1980 Corvette: Service Bulletin: Rear Wheel Spindle Yoke Snapping Noise

Source: Chevrolet Dealer Service Technical Bulletin

Bulletin No: 80-T-44

Date: June, 1980

FIGURE 1

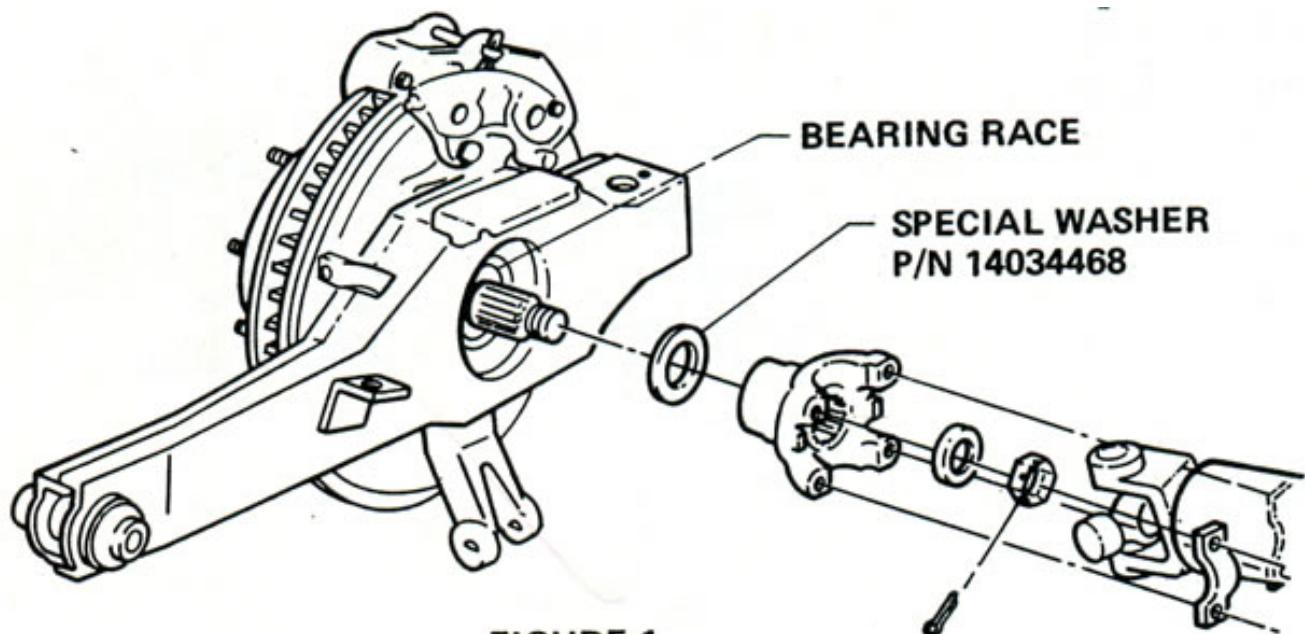
Owners of 1980 Corvettes, primarily those equipped with a manual transmission, may experience a snapping or crunching noise from either or both rear wheel locations during torque reversals and during acceleration or deceleration. This noise is the result of scuffing of the rear wheel spindle yoke against the inner wheel bearings inner race.

This condition can be corrected by installing a special Moly coated washer (P/N 14034468) between the spindle yoke and the inner wheel bearing (see Figure 1). Steps 2 through 8 of the following Service Procedure should be performed at each rear wheel.

FIGURE 2

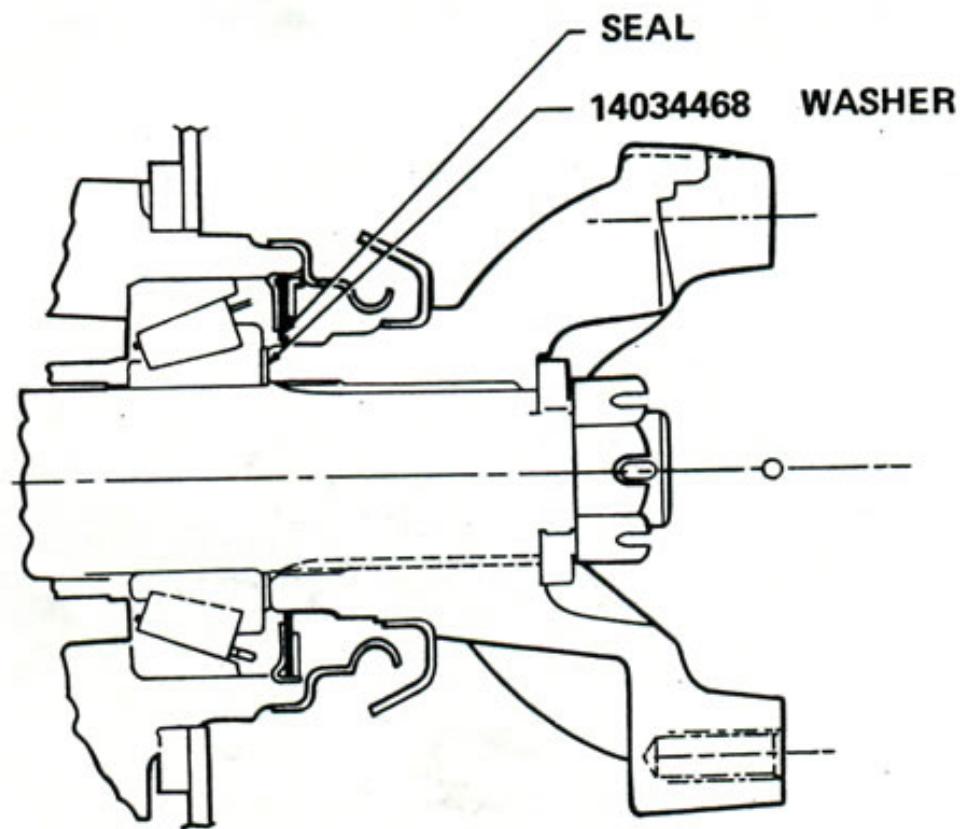
6. Install lubricated washer and spindle yoke on spindle such that washer is between yoke and the inner wheel bearing and completely inside the seal (see Figure 2). NOTE: Use care to avoid nicking the seal lip or trapping it between the washer and the bearing race. If the seal life is damaged, the seal must be replaced.
